file No. ~~31~~ 31. sketch.
Wise County.

Surveyors Sketch & Statement
 relative to the positions of Swamp
 tion survey (P. 475. P. 477) etc.

12 Miles N 70 W. of
 Decatur.

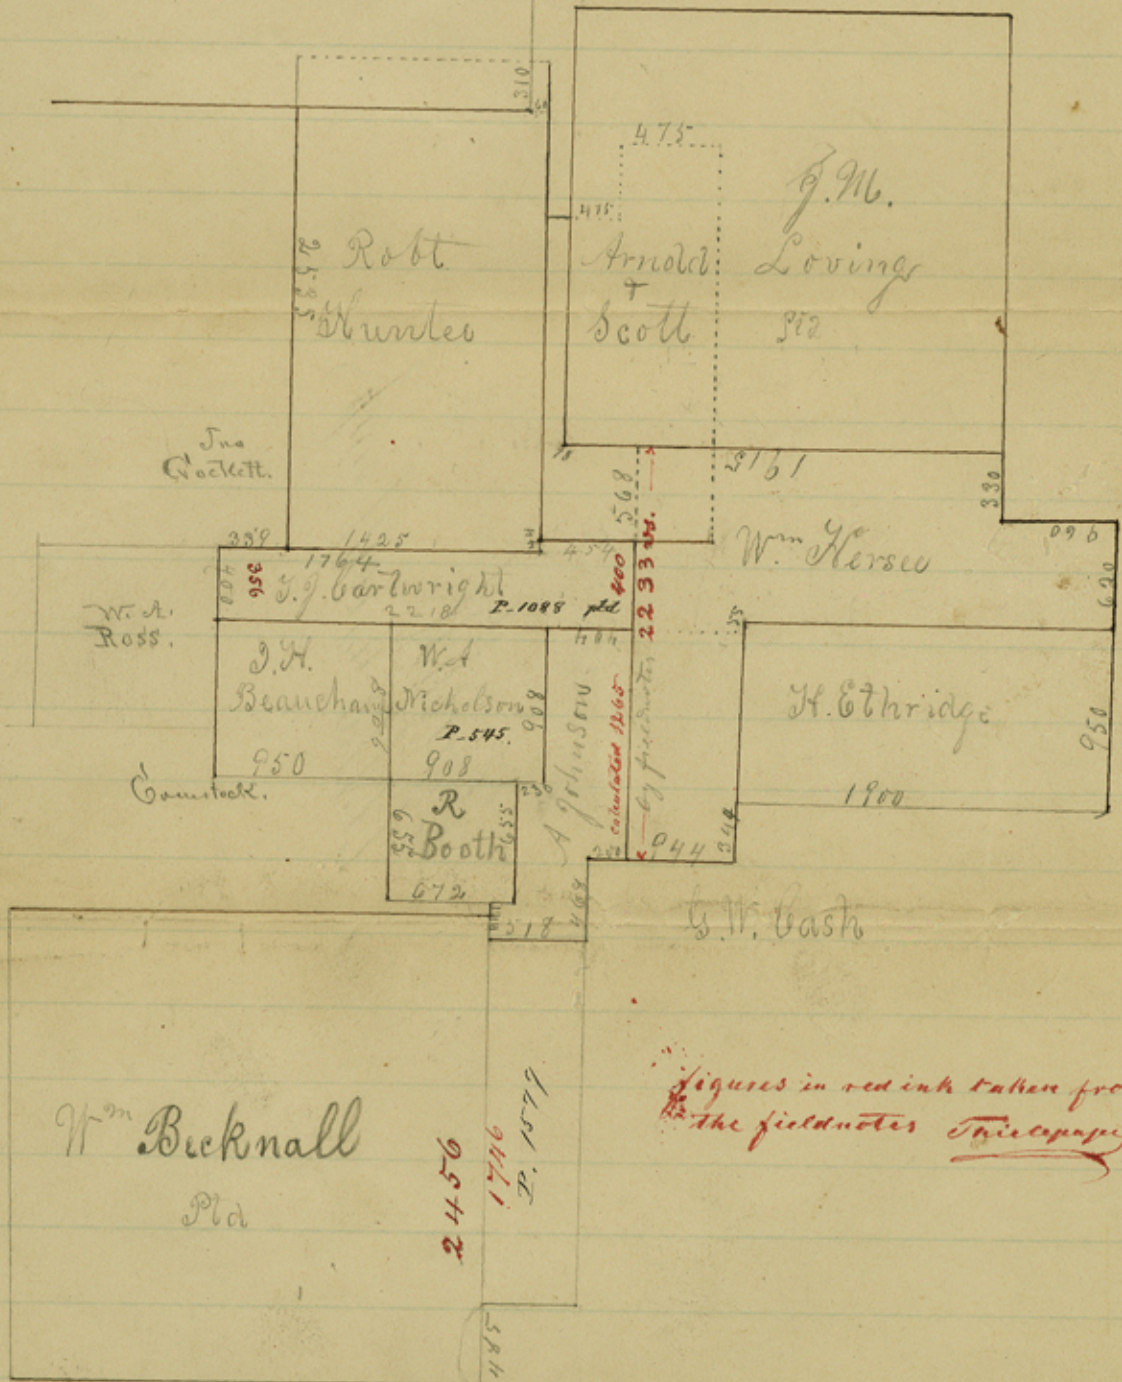
You will find enclosed another sketch of surveys & tracts on Dry Creek W. Co. Ga. showing more definite their true positions relative to each other by actual measurement on the ground. I must admit an error made in my last plat forwarded sometime since, and since then I have made a careful survey of all therein mentioned tracing the lines & bands in accordance with the calls &c. I find that by running the J. M. Loving from its connecting point, which is the N. W. corner of the H. C. Thridge. North 950 rods & West 1300 rods runs entirely across the Arnold & Scott with the exception of 78 rods and its S. W. corner is only 568 rods North & 78 rods East from Arnold & Scott's S. W. corner as shown in said plat. There can be no mistake in this as the Arnold & Scott has clearly defined corners with bearings

To correspond, all of which I found with exception of its S.E. Corner which I could not positively define as the bearings were destroyed. I found also a conflict between the Robt Hunters & Wm Watson, which is contrary to all the maps. By running from Hunter's S.E. Cor (which is 44 vs South of Arnold & Scott's S.W. Cor) North passing 60 vs East of Watson's S.E. Cor. and thence me 310 vs North of Scid Cor as shown by plat, hence the two surveys last mentioned being farther North than was supposed, has partly caused the vacancy between the surveys on the South & Wm Becknell on the north.

I also find an error in the connecting point of W.A. Nicholson, a line running East from Nicholson's N.E. Cor will strike 55 vs South of the Ethridge, N.W. Cor. as shown by the dotted lines across the Hesse, and the distance across is 1348 vs. Nicholson's boundary lines are also short by 42 vs. The survey of Cardright Nicholson & Booth was actually made upon vacant land as no other survey can by no means cover the ground. The

Bicknell Can not Come any farther
North than its distance Calls,
neither Can the Surveys North
go any farther South as most
all of their Corners are well defin
ed. You will also find a Conflict
between Arnold & Scott & the Wm
Hershey. And the J. M. Loring
running East from its beginning
doe not reach the Cook & Schoel
lands by measurement.

This sketch is not satisfactory. —
 It is not far enough extended
 to show the consequences, which
 it will have on other surveys
 and how these are to be corrected.
 It gives the Hattron
 survey a wrong position and the
 surveyor has to show where the
 discrepancy lies; also it gives
 the Etheridge survey a wrong
 position and the surveyor has
 to show that its connection
 is erroneous. If the Ether-
 ridge survey is plotted correct
 the Horse and the Loving survey
 will conflict with the Cooke to
 Schoolland. March 15/78
